CABELL-HUNTINGTON HOSPITAL
1340 Hal Greer Boulevard
Huntington, West Virginia 25701

December 27, 1988

Re: Amendment to Radioactive Materials License #47-00404-02

*Temporary
RUBBER
STAMP*

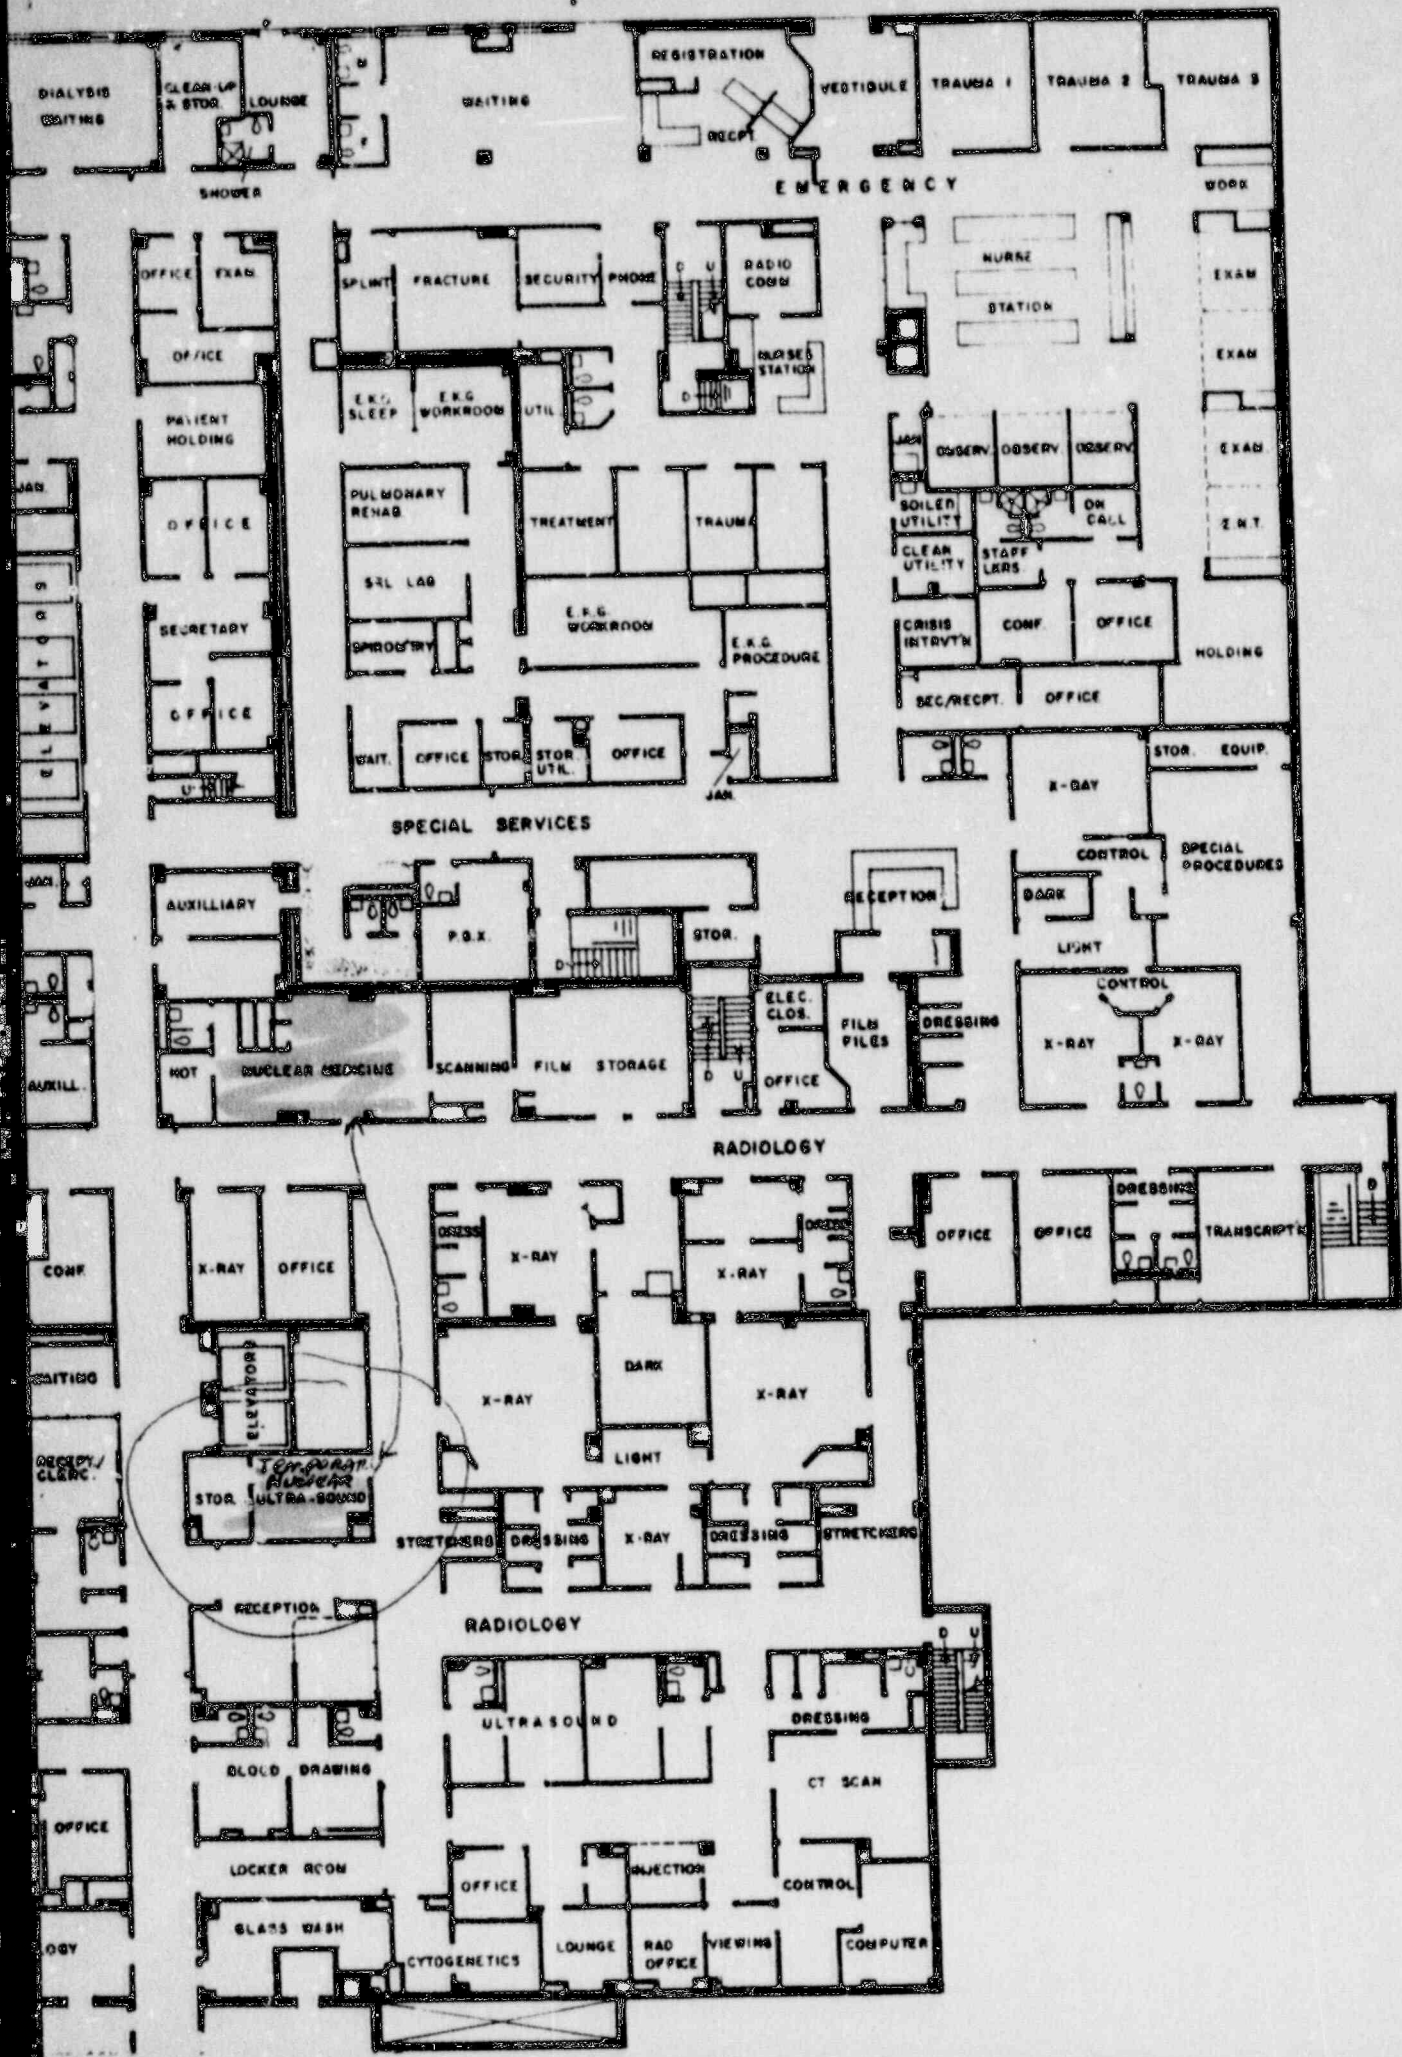
3. During renovations we wish to move one of our gamma cameras to a vacant room approximately 20 yards down the hall from our existing department. This will allow us to continue operations during renovations. We confirm that we will follow all radiation safety procedures the same as if this room was directly attached to our department. Radioactive material will be transported to this room in a leaded container. We will not use Xenon-133 in this room. Attached is a sketch of this temporary imaging room.
